Access Compliance Report

Public Rights-of-Way

Intersection ID: 16077	Main Street: ELLENWOOD_PL	Cross Street: YORKSHIRE_DR	Location: NW
ADA ID: 17729E11EC7F	Ramp Type: PerpDiag	Initial Pass/Fail: Fail	Overall Compliance: No
Severity Score: 12.5			
Codes/Mitigation Info/Possible Solution		Field Measurements/Component Compliance

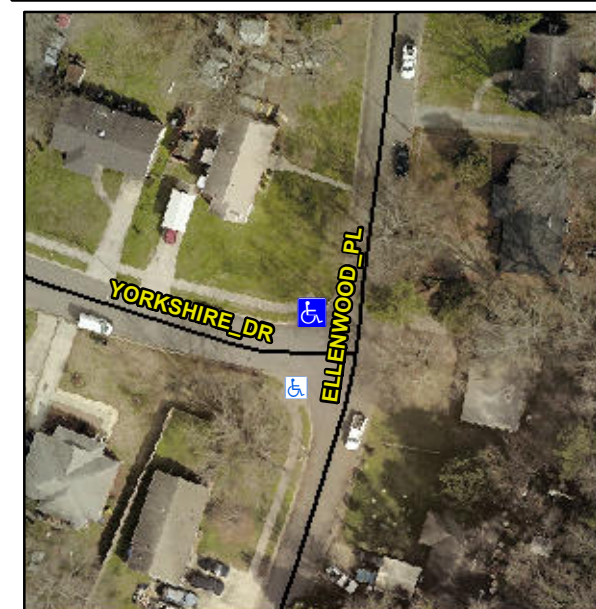
Not Found, R304.2.2

Compliance	Description	Data	Compliance	Description	Data
N/A	Ramp Length (in)	60.0	No	Ramp Slope (%)	9.3
Yes	Ramp Width (in)	48.0	Yes	Ramp XSlope (%)	0.1
N/A	Flare Type LT	N/A	N/A	Flare Type RT	N/A
N/A	Flare Slope LT (%)	N/A	N/A	Flare Slope RT (%)	N/A
N/A	Flare Traversable LT?	N/A	N/A	Flare Traversable RT?	N/A
N/A	Landing Length (in)	N/A	N/A	DWS Provided?	N/A
N/A	Landing Width (in)	N/A	N/A	DWS Contrast?	N/A
N/A	Landing Slope (%)	N/A	N/A	DWS Length (in)	N/A
N/A	Landing X Slope (%)	N/A	N/A	DWS Full Width?	N/A
N/A	Landing Curb? (Y/N)	N/A	N/A	DWS Offset (in)	N/A
N/A	Shared Landing?	N/A			
N/A	Gutter Ponding?	N/A	N/A	Gutter Slope (%)	N/A
N/A	Gutter Lip Ht (in)	N/A	N/A	Gutter X Slope (%)	N/A
N/A	Painted X Walk1?	No	N/A	Painted X Walk2?	No
	X Walk 1 Direction	To S		X Walk 2 Direction	To E
N/A	X Walk 1 Width (in)	N/A	N/A	X Walk 2 Width (in)	N/A
	X Walk 1 Slope (%)	6.0		X Walk 2 Slope (%)	0.7
	X Walk 1 X Slope (%)	0.4		X Walk 2 X Slope (%)	1.9

Remove & Replace Curb Ramp With Two New Directional Ramps or Equivalent.
